XAUI Jitter Tolerance Mask Proposal

Receiver Jitter Tolerance Mask

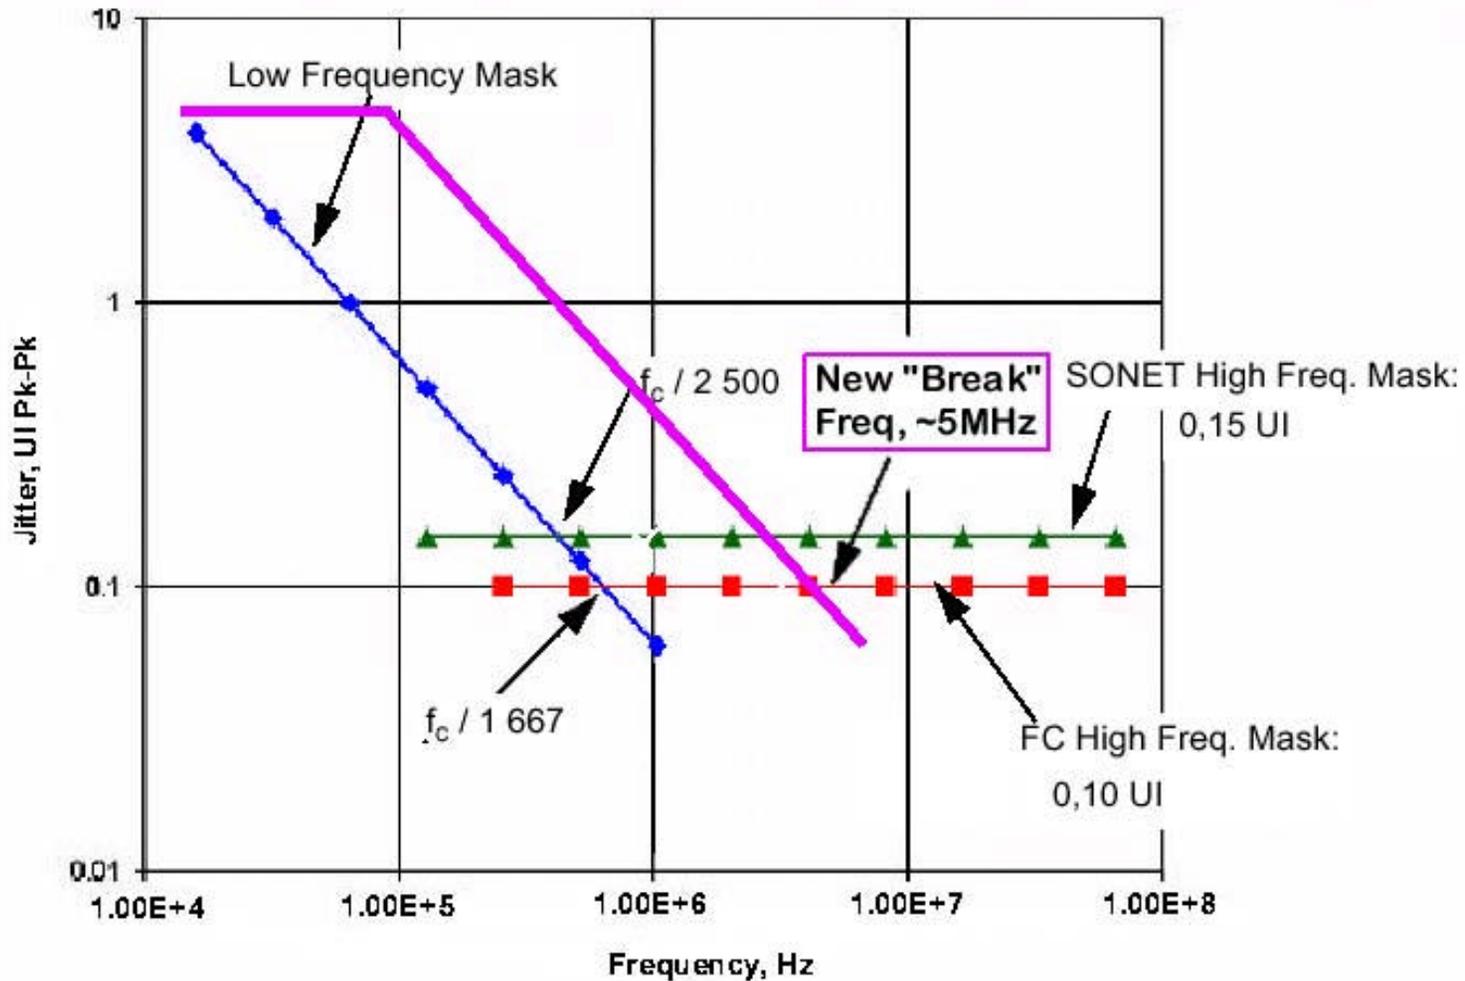
- Old Sonet standard based on outdated SAW filter technology.
- Current systems employ CDRs with several times higher bandwidth than that specified by old Sonet standard.
 - Current systems work perfectly using new higher bandwidth CDRs. (No max limit in any spec today)
- Update the standard to reflect changes in technology.
 - Higher bandwidth will allow the use of smaller capacitors in CDR designs → higher level of integration
